Special Public Works Committee Meeting
Wednesday, August 30, 2023
1:00 p.m.
Town Hall

THOUGHTS FROM ADA WALKABOUT TOWN OF SHEPHERDSTOWN JEFFERSON COUNTY, WEST VIRGINIA

TECHNICAL ASSISTANCE REPORT

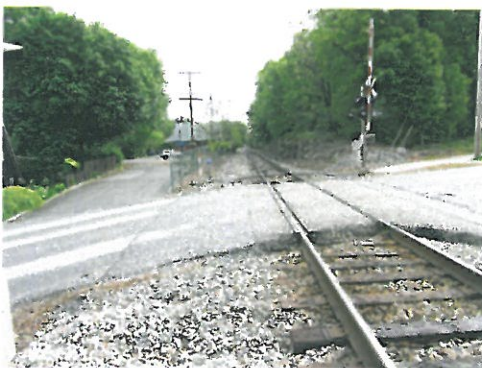
However, the resurfacing resulted in the ramp on the north side of E. German being removed. In addition, the crosswalk striping was not renewed. Note that, as shown here, the signing of this location (pedestrian warning sign with a downward arrow) indicates that this is a crosswalk. The arrangement is confusing and raises liability concerns. The situation should be discussed with the WVDOH. If nothing else, it appears that the downward arrow plaque should be removed.
